Wisconsin Department of Transportation

NOTICE TO ALL CONTRACTORS:

Proposal #16: Project ID 3760-00-70
CTH H; CTH KR to Braun Rd
CTH KR to Braun Rd
CTH H
Racine County

This is Addendum No. 01, which provides for the following:

Addendum No. 01
ID 3760-00-70
Revised Sheet 22
January 4, 2019

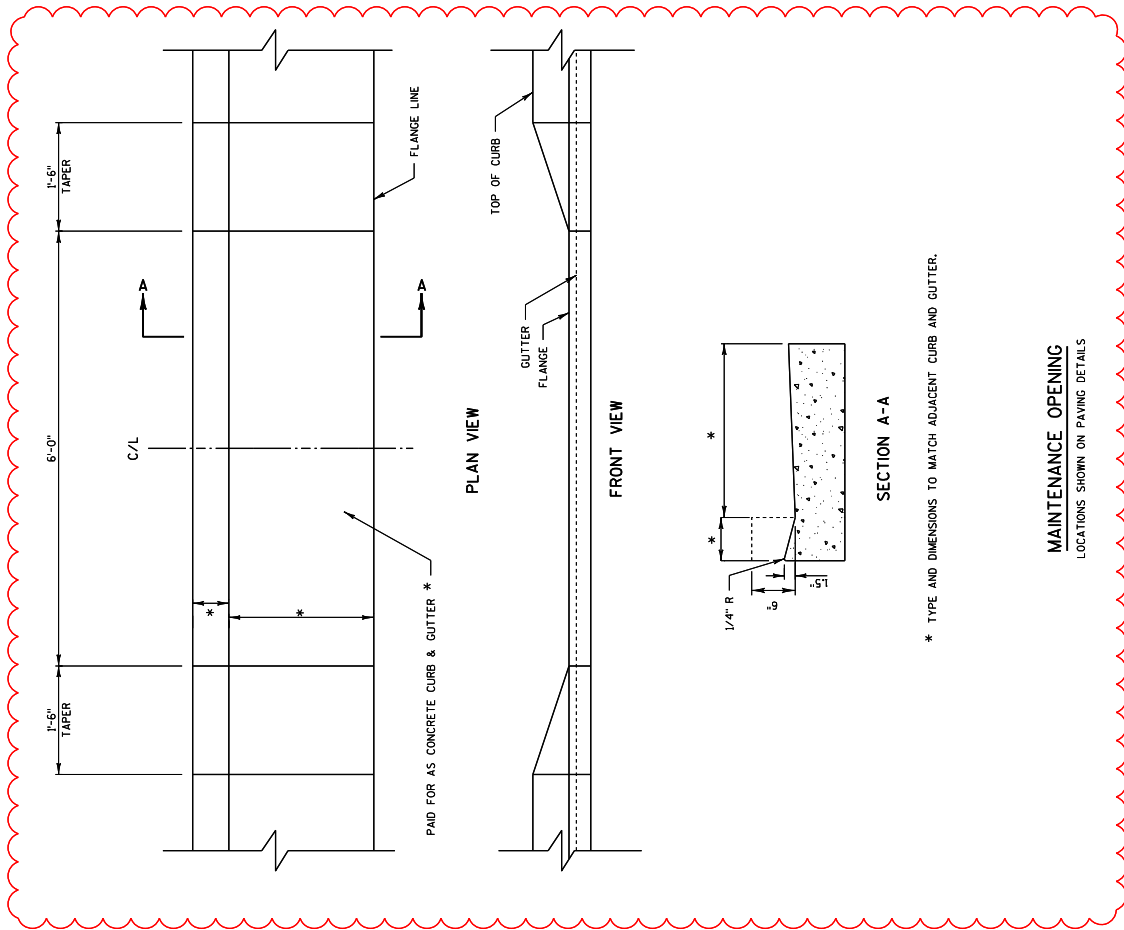
Revised Plan Sheets	
Plan Sheet	Plan Sheet Title (brief description of changes to sheet)
22	Construction Detail (added maintenance access detail)
42	Plan Details (Labeled Maintenance Opening)
43	Plan Details (Labeled Maintenance Opening)
45	Plan Details (Labeled Maintenance Opening)
47	Plan Details (Labeled Maintenance Opening)
49	Plan Details (Labeled Maintenance Opening)
50	Plan Details (Labeled Reverse Curb and Transition Location)
162	Traffic Signal Plan (Revised monotube pole)

Addendum No. 01
ID 3760-00-70
Added Sheet 161A
January 4, 2019

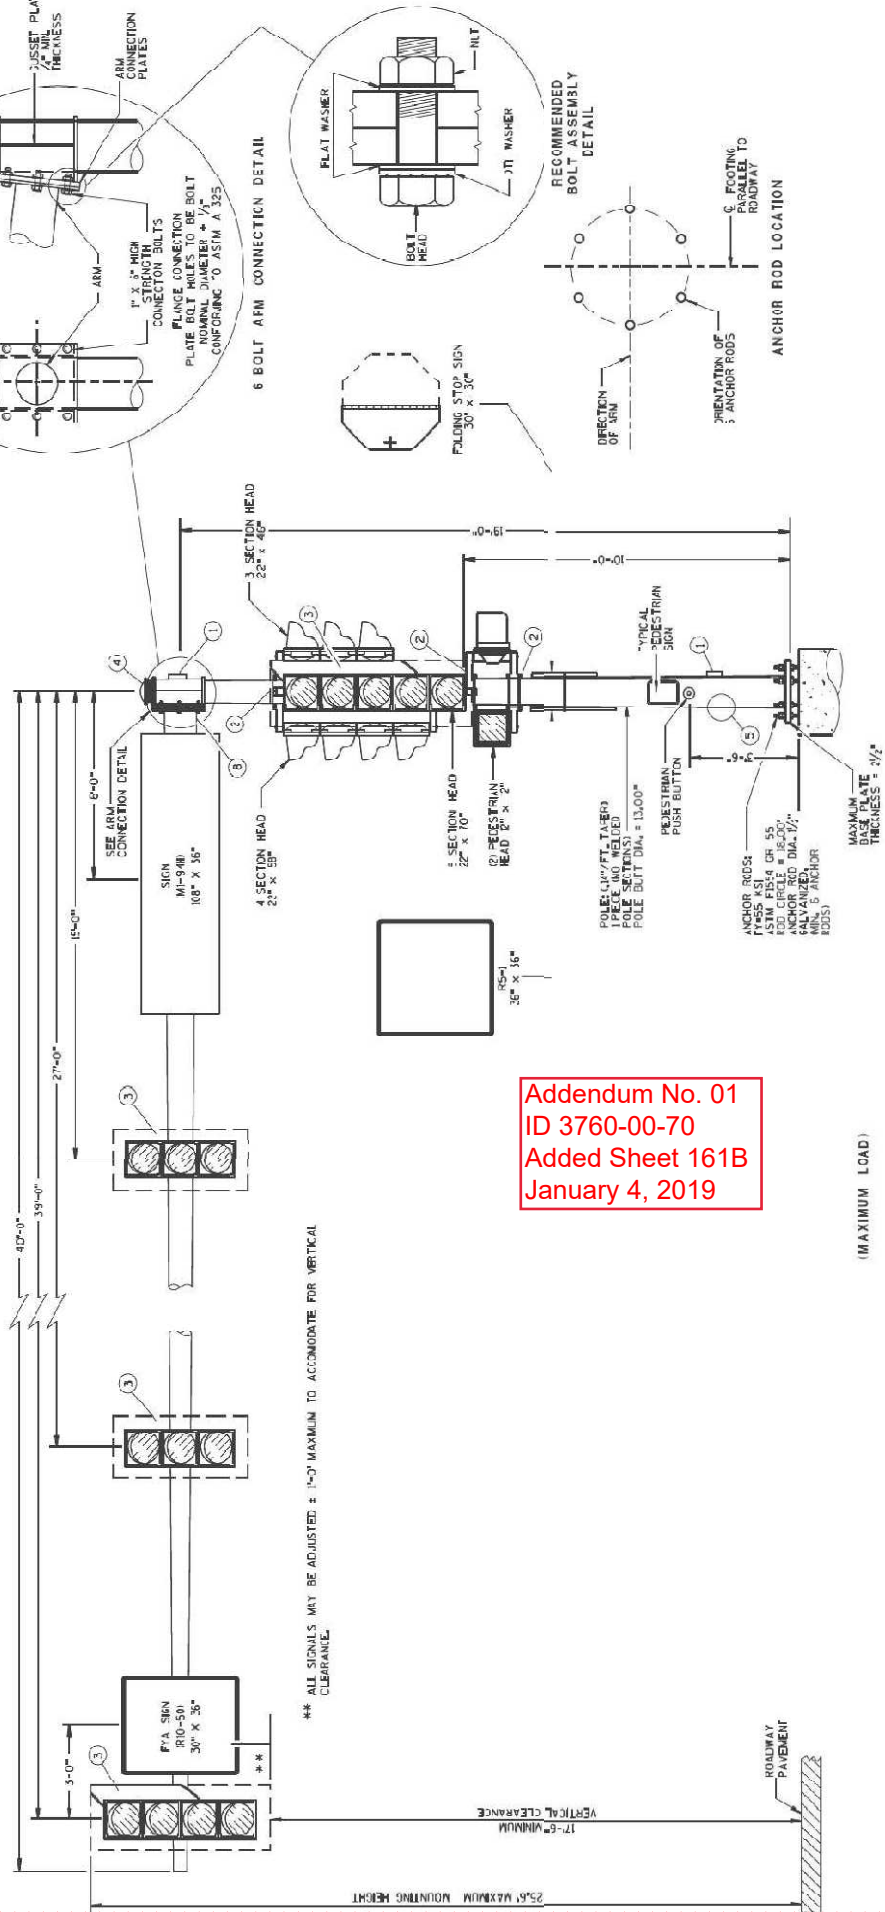
Added Plan Sheets	
Plan Sheet	Plan Sheet Title (brief description of why sheet was added)
161A	Traffic Signal Details (new monotube detail)
161B	Traffic Signal Details (new monotube detail)
161C	Traffic Signal Details (new monotube detail)
161D	Traffic Signal Details (new monotube detail)

Addendum No. 01
ID 3760-00-70
Revised Sheet 166
January 4, 2019

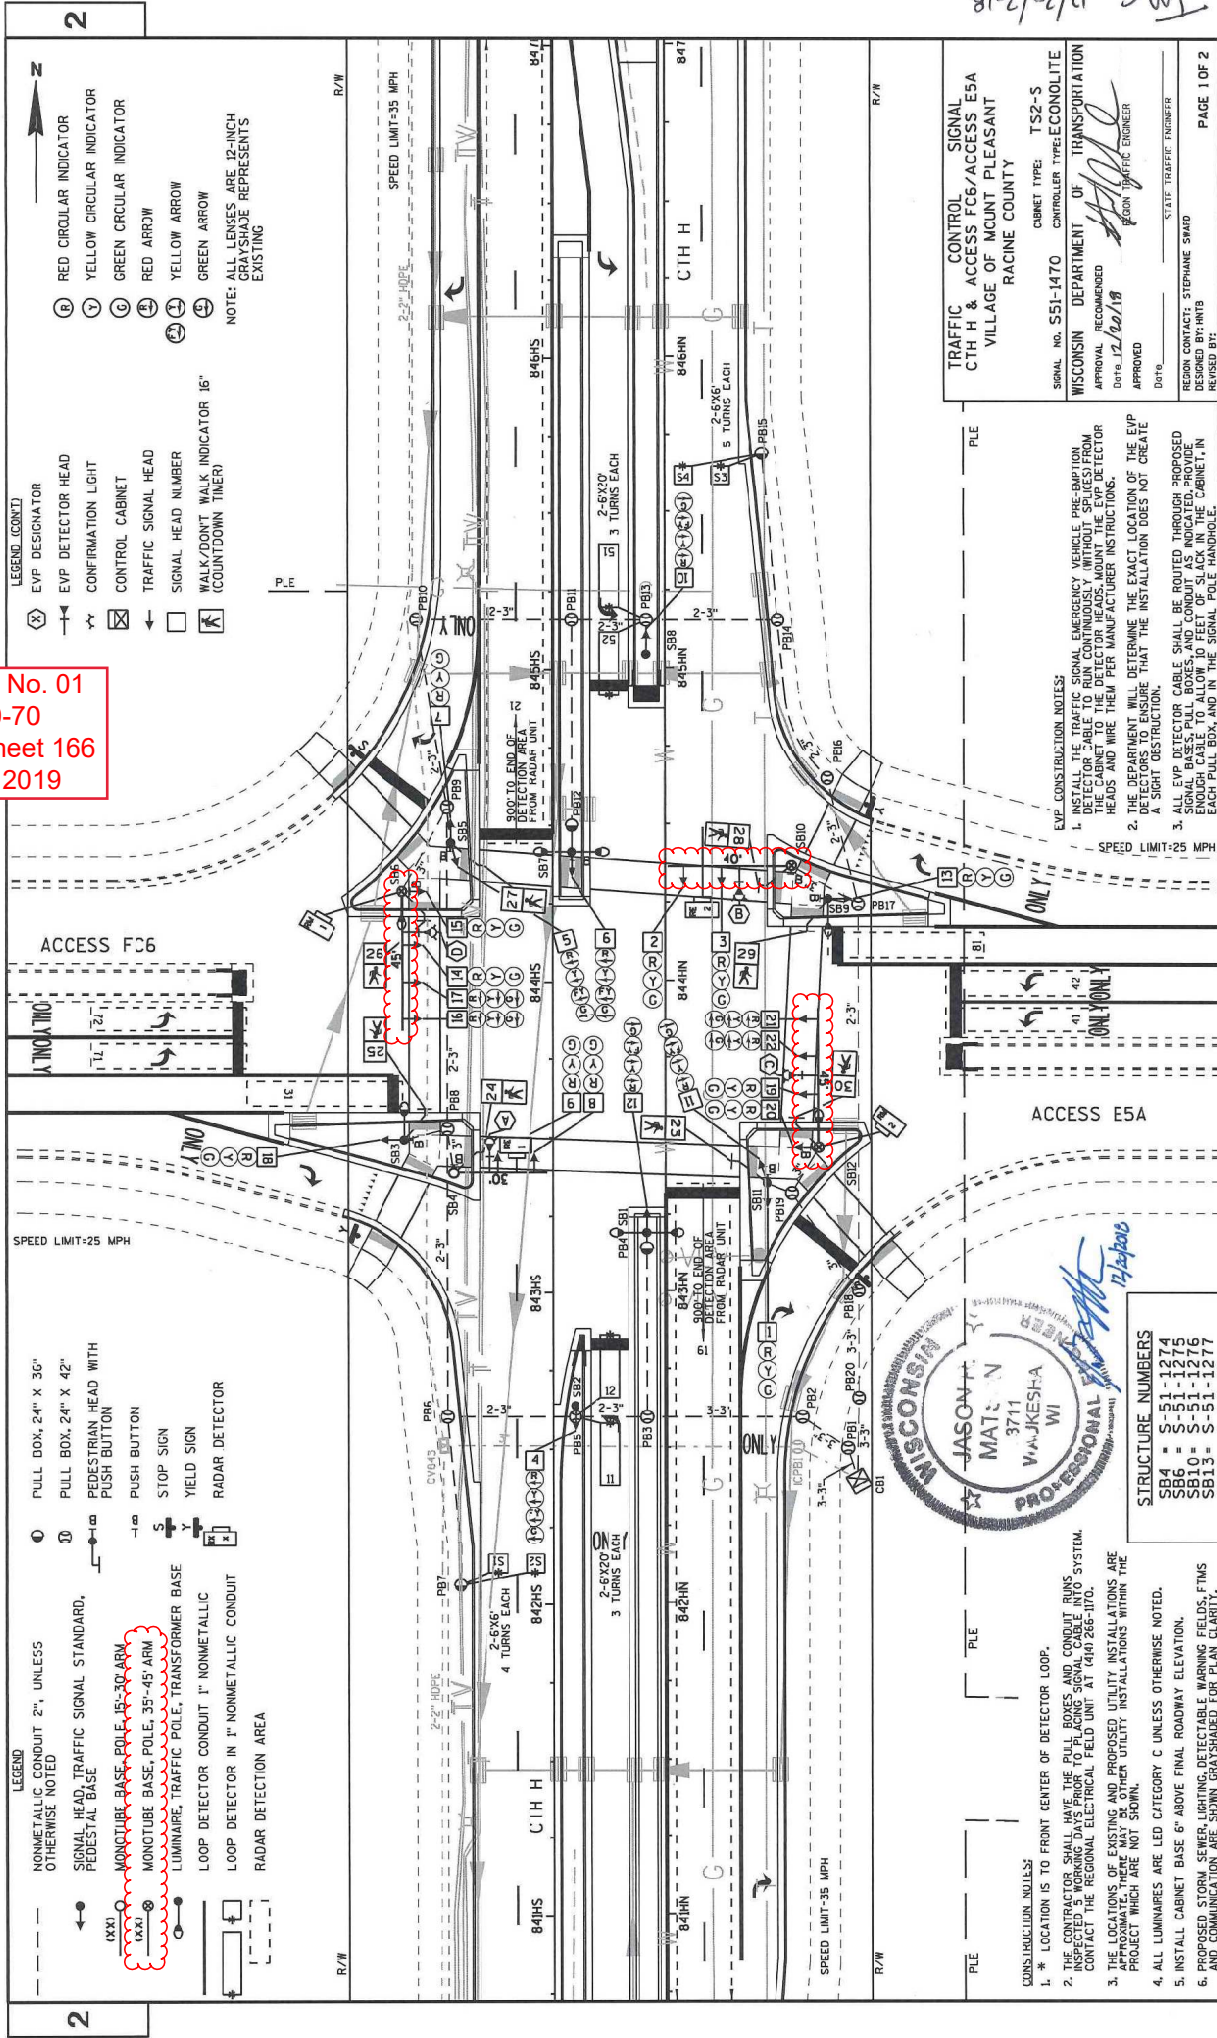
163	Sequence of Operation (Revised date)
166	Traffic Signal Plan (Revised monotube pole)
167	Sequence of Operation (Revised date)
176	Temporary Traffic Signal Plan – Pre-Stage 1 (Signal revised)
177	Temporary Traffic Signal Plan – Stage 1 (Temporary luminaire correction)
178	Temporary Traffic Signal Plan – Stage 2A (Temporary luminaire correction)
179	Temporary Traffic Signal Plan – Stage 1 (Temporary luminaire correction, revised construction note)
180	Temporary Traffic Signal Plan – Stage 4A (Temporary luminaire correction)
181	Temporary Traffic Signal Plan – Stage 5A (Temporary luminaire correction)
182	Temporary Sequence of Operations – Stages 1, 2A, 3 (Revised general notes)
184	Temporary Traffic Signal Plan – Pre-Stage 1 (Added temporary luminaires)
185	Temporary Traffic Signal Plan – Stage 1 (Added temporary luminaires)
186	Temporary Traffic Signal Plan – Stage 2A (Added temporary luminaires)
187	Temporary Traffic Signal Plan – Stage 3 (Added temporary luminaires)
